Project CENTRAL / RIDGE Rd Intersection

Project Number 472 83057000 001 / Index Code 706805

SWS change:

See Drawing ON BACK

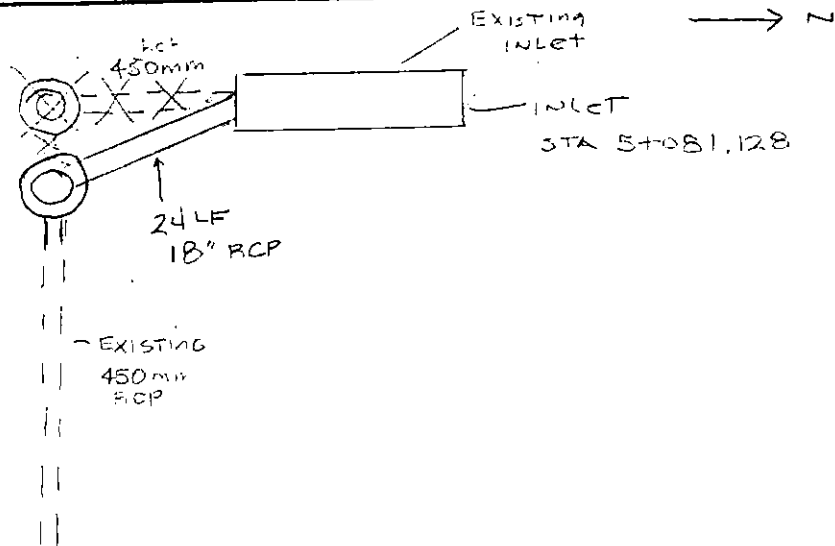
REMOVED SWS MANHOLE IN TOTAL DRIVEWAY STA

REMOVED SWS PIPE 18" RCP

USED EXISTING FLOW LINE GRADE @ INLET LAID 18" PIPE SOUTHEASTERLY

Removed 18" RCP South to MH
Removed MH @ STA
